ADDENDUM NO. 2

PROJECT: NW Connell and NW Garibaldi Street Improvements, No. 10485

DATE: June 27, 2013

This addendum to the contract documents is issued to clarify, correct, and supplement the drawings and contract documents issued as "NW Connell and NW Garibaldi Street Improvements", bid closing date July 2, 2013.

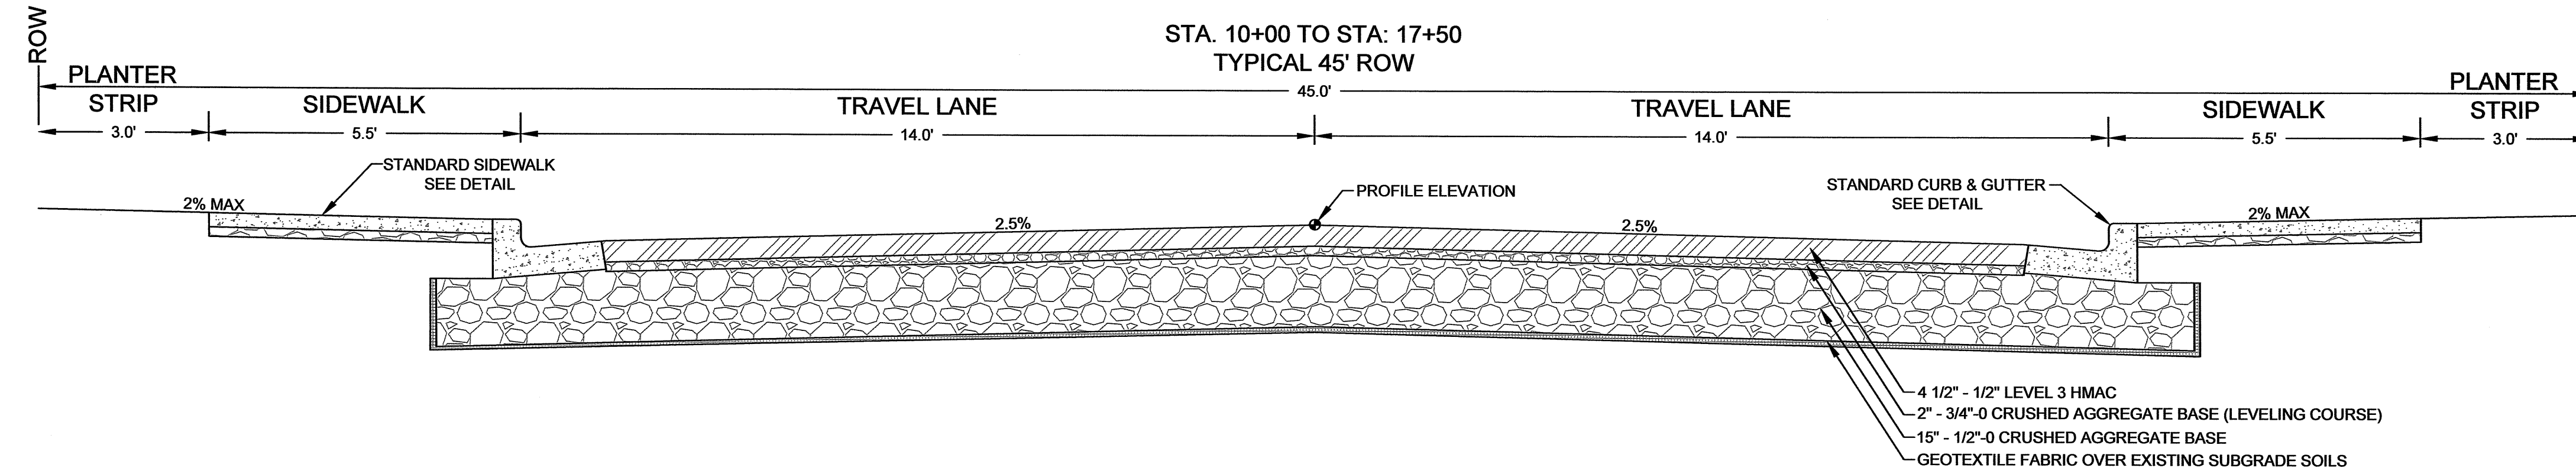
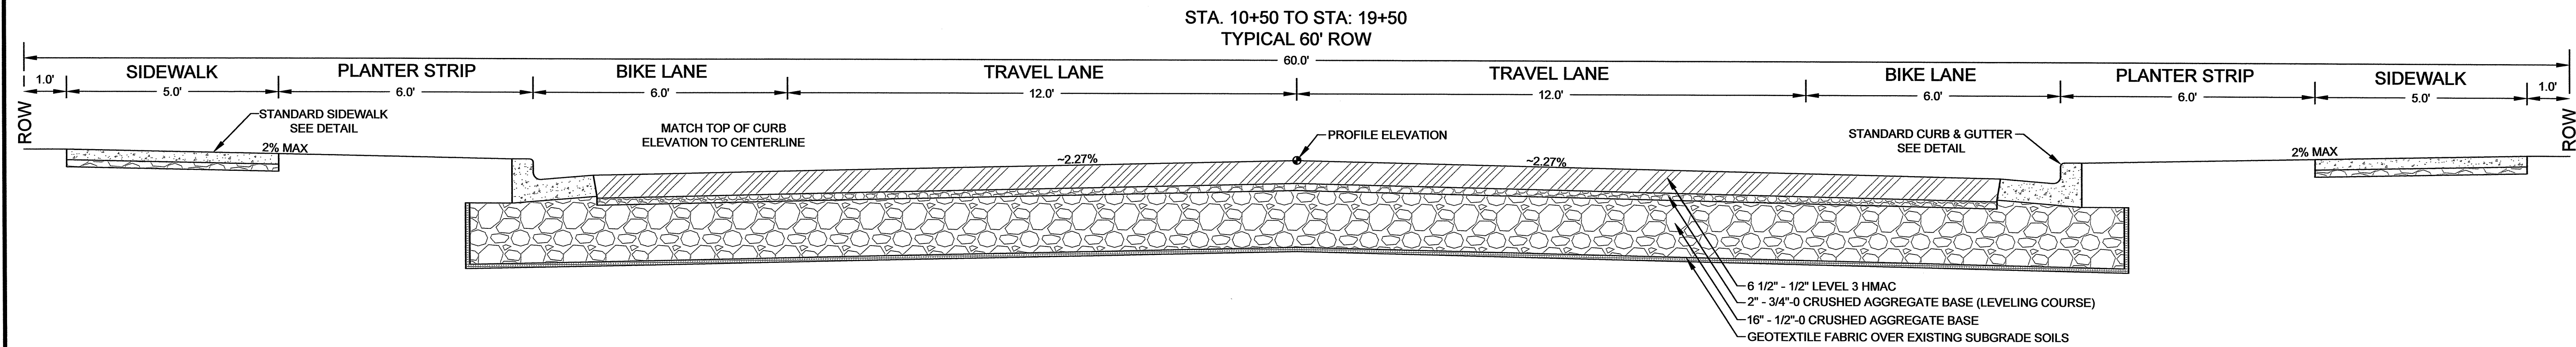
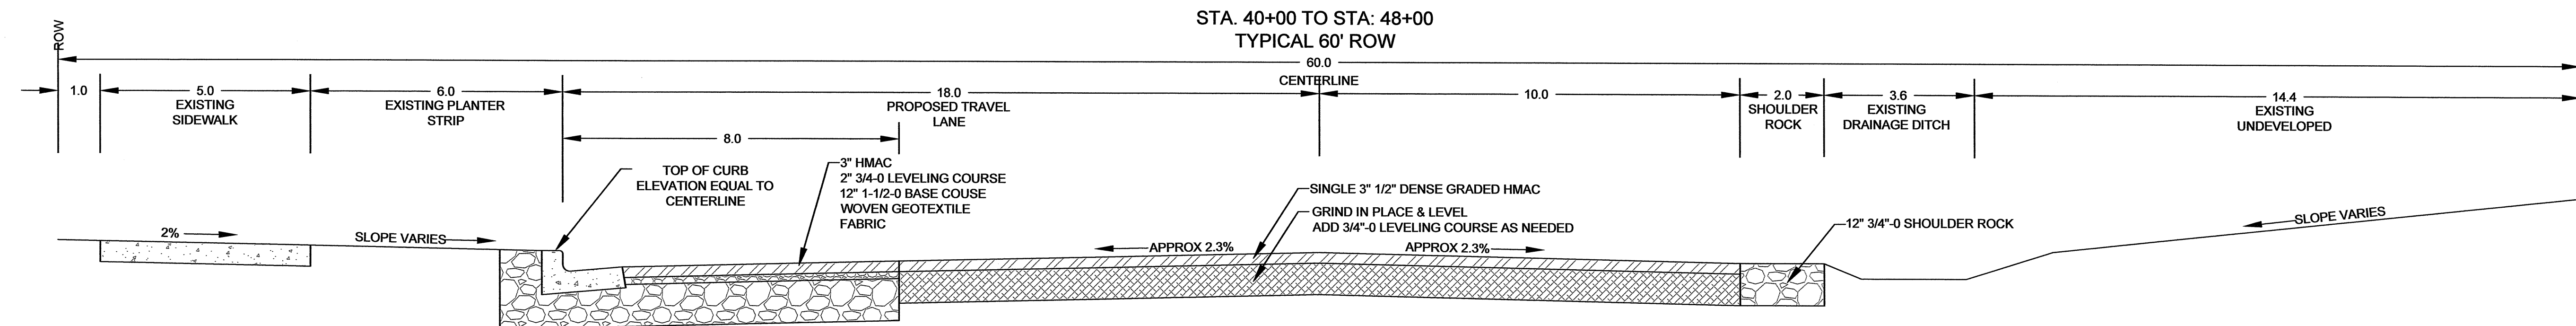
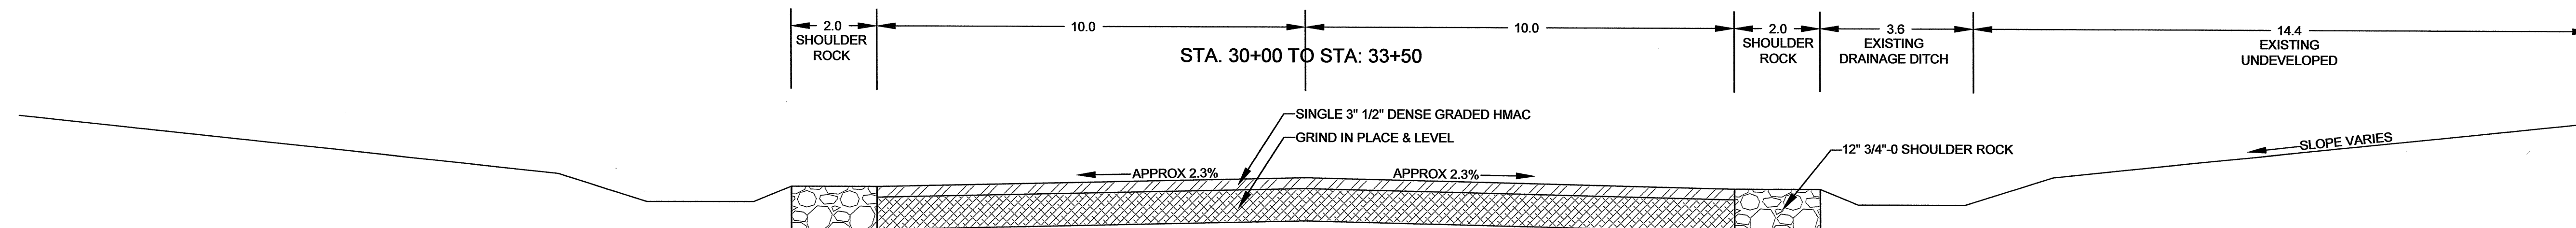
Page C-100 (11 of 32):

On the top section NE Garibaldi St, the 7' travel lane should be 14' and the sidewalk on the right side should be labeled as a sidewalk, not a travel lane.

SHEET NO.
C-101

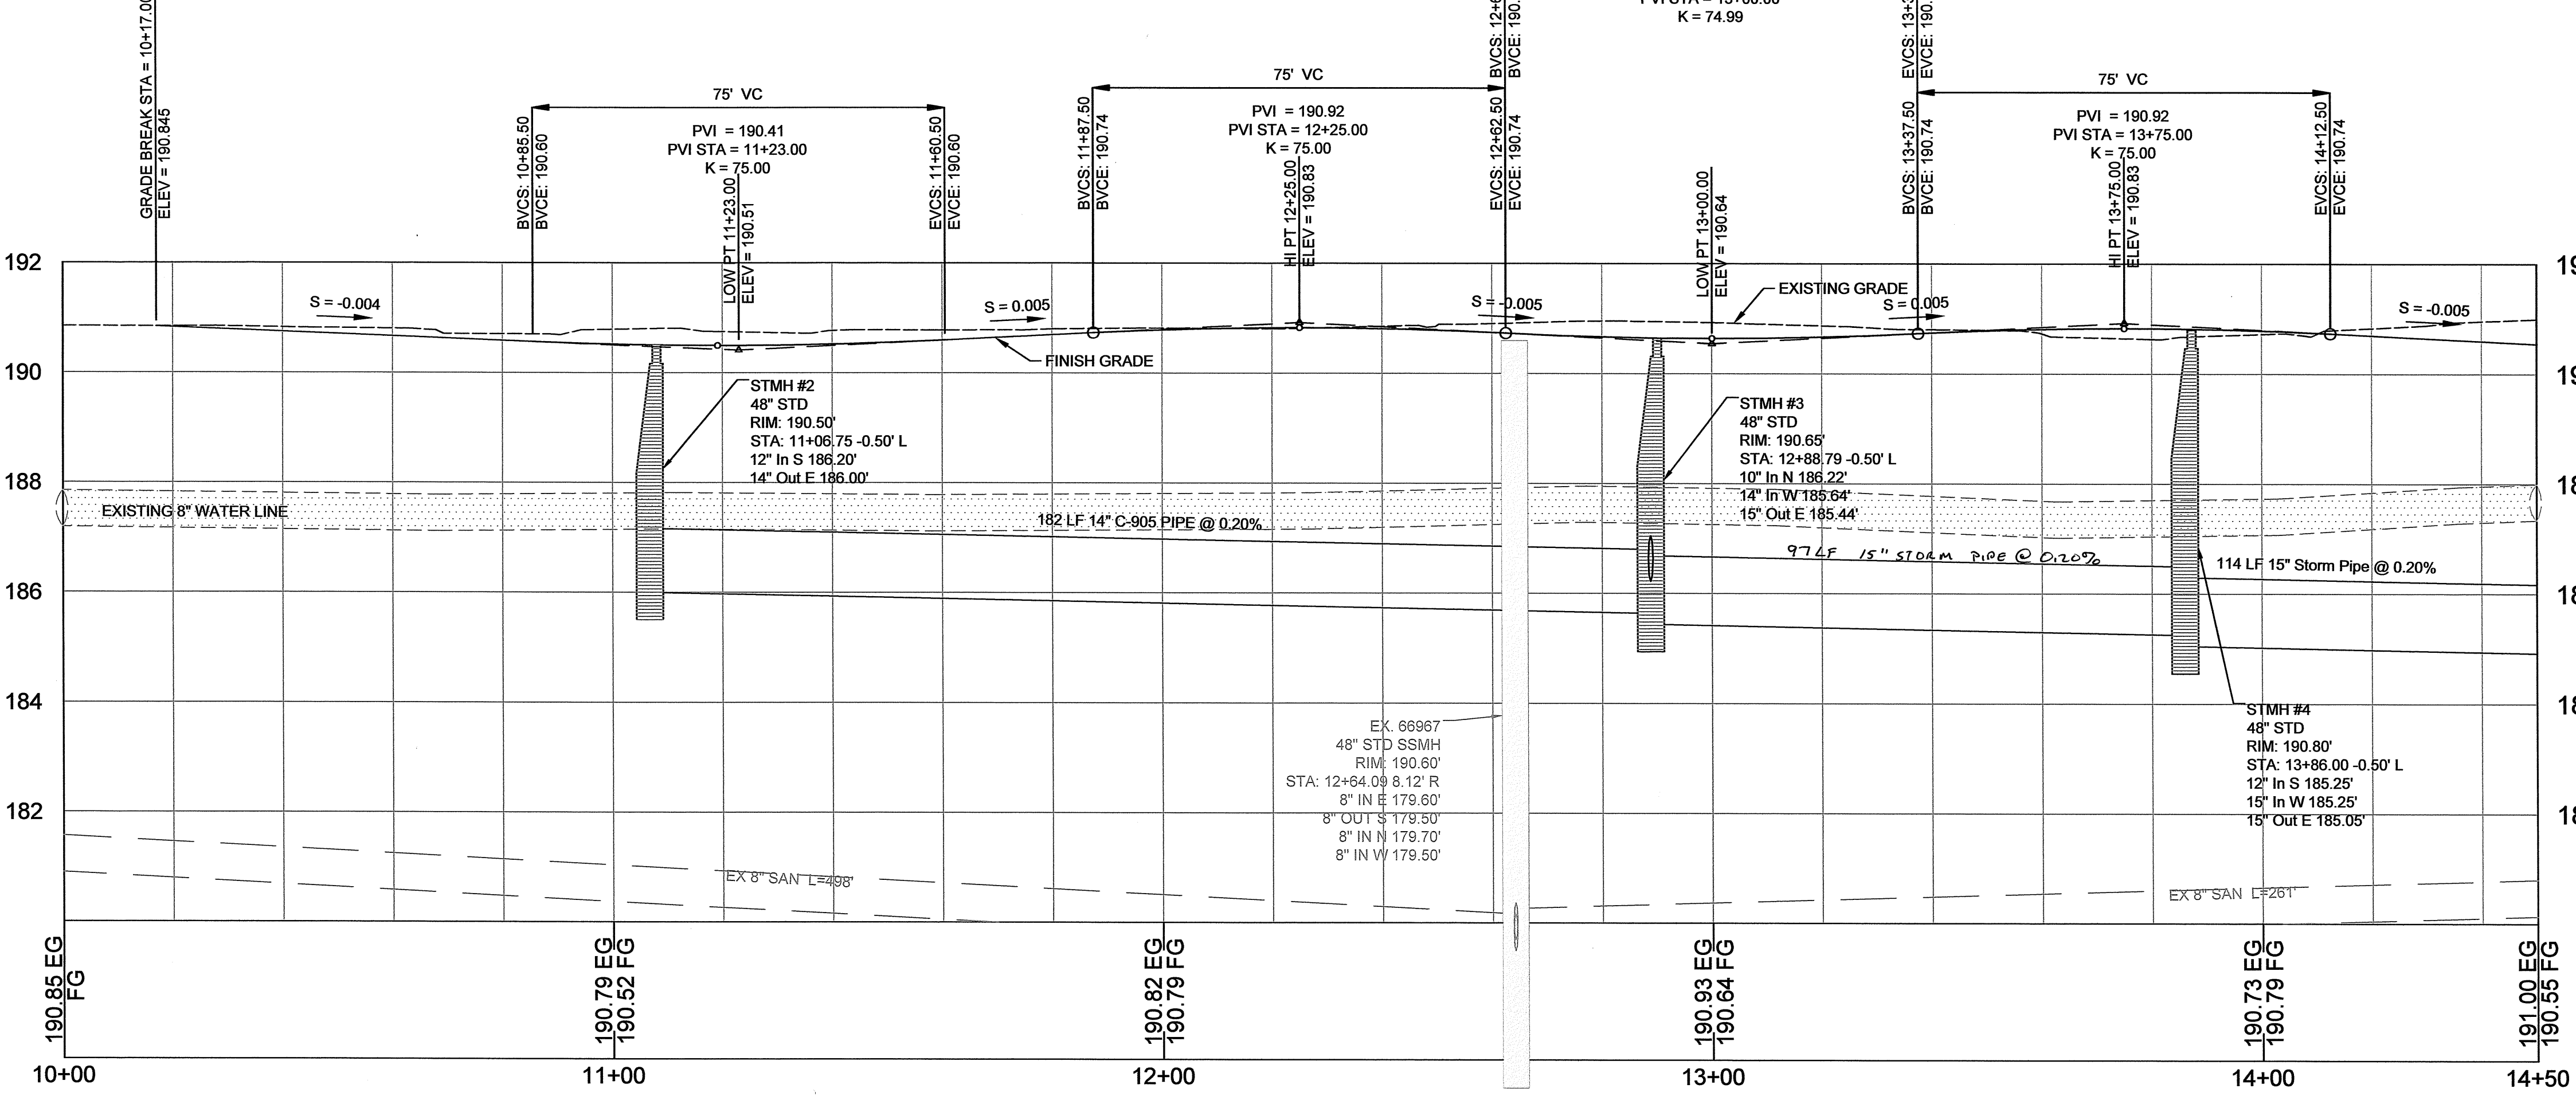
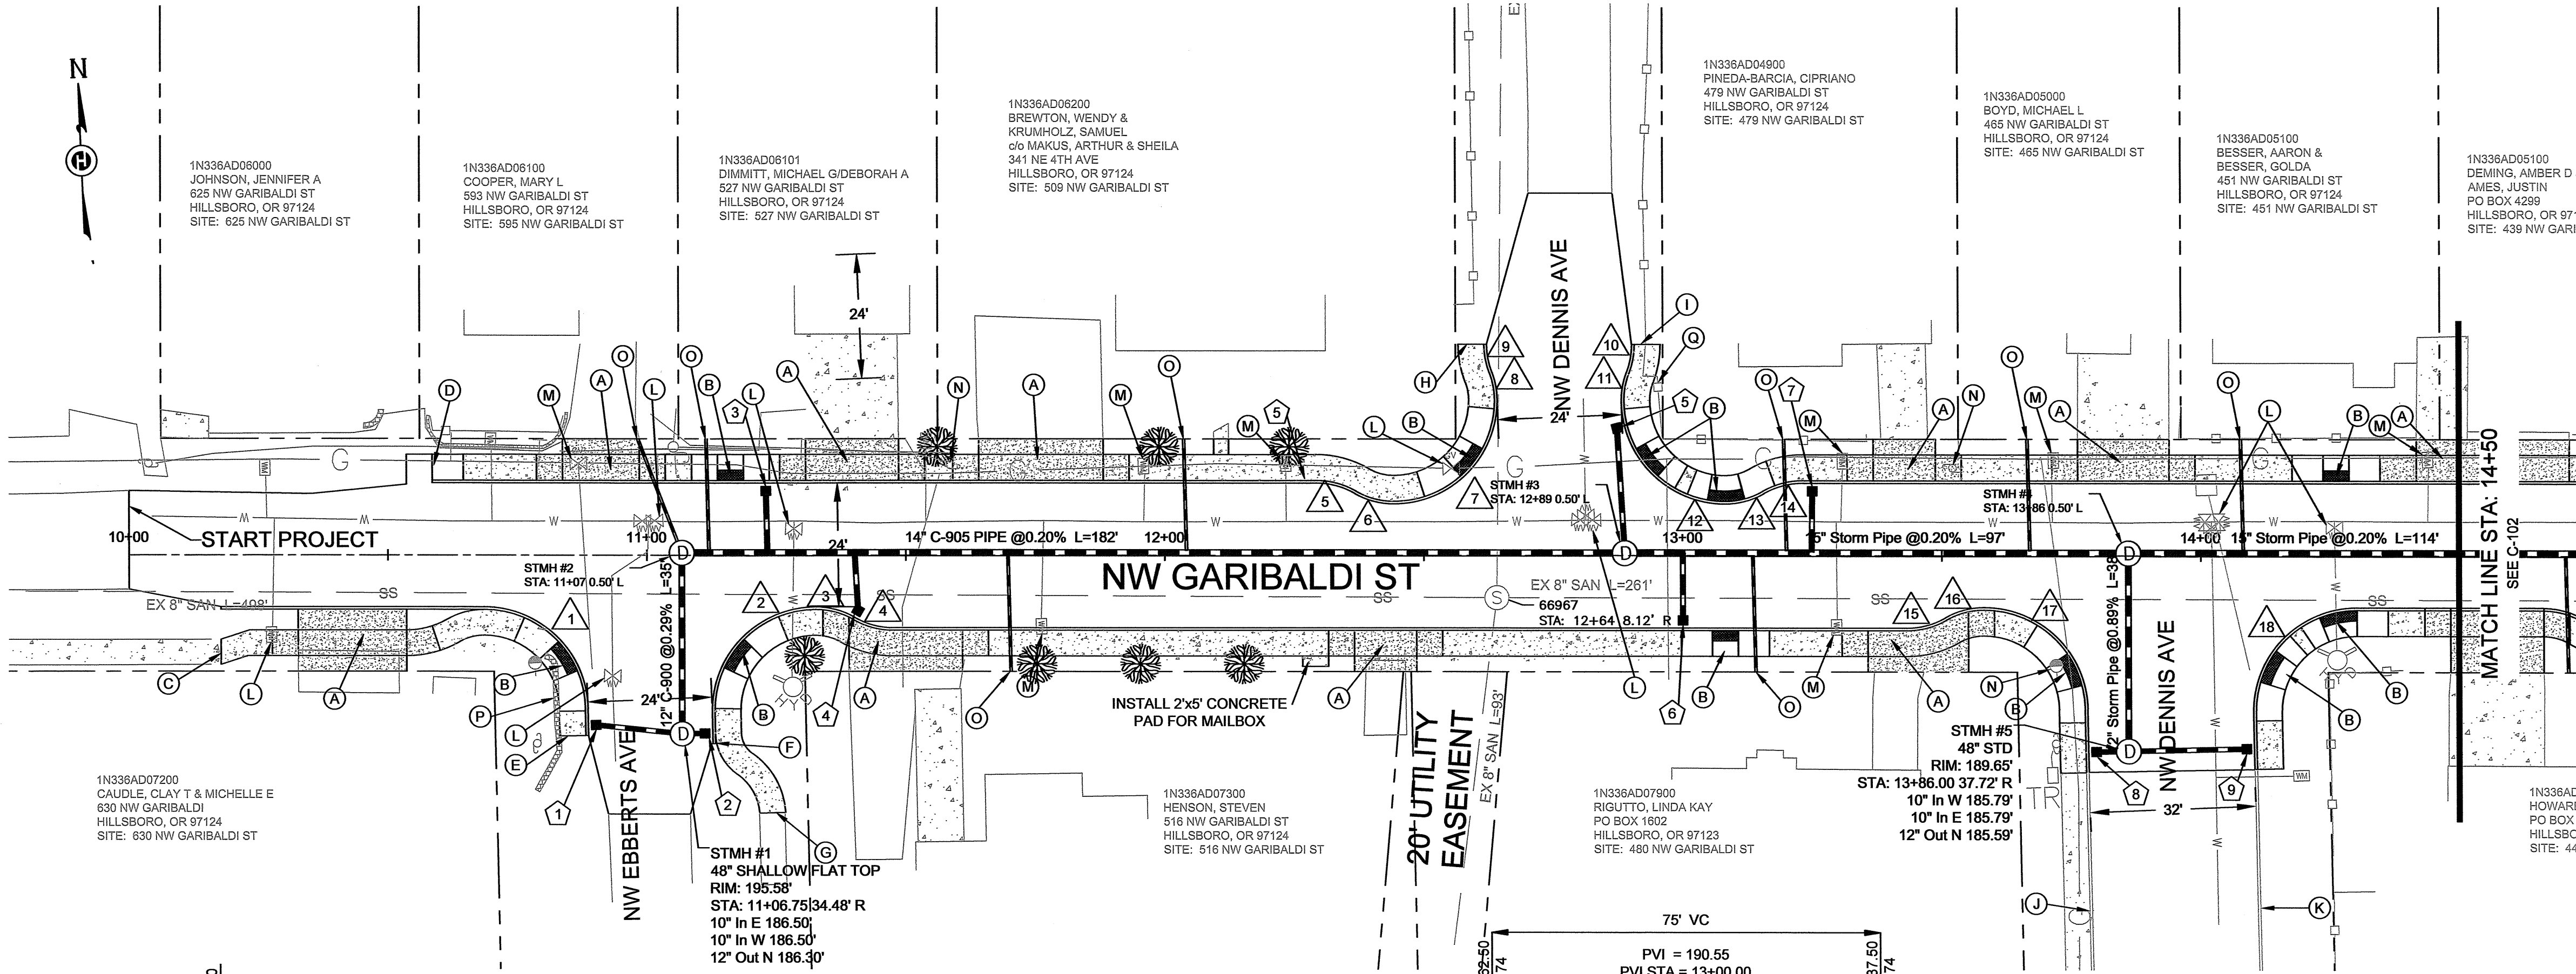
Page C-101 (14 of 32):

1. Some of the notes for STMH #1 and #3 are missing. Add the following notes for STMH#1:

STMH #1	STMH #3
STA 11+07 34.5' R	STA 12+89 .5' L
48" STD MANHOLE	48" STD MANHOLE
RIM = 195.58	RIM = 190.65
IE IN = 186.50 10" E & W	IE IN = 186.22 10" N
IE OUT = 186.30 12" N	IE IN = 185.64 14" W
	IE OUT = 185.44 15" E

2. The storm pipe material from STMH #1 to STMH #2 should be 12" C-900.
3. The storm pipe material from STMH #2 to STMH #3 should be 14" C-905
4. All Catch Basin Runs should be 10" C-900 pipe.
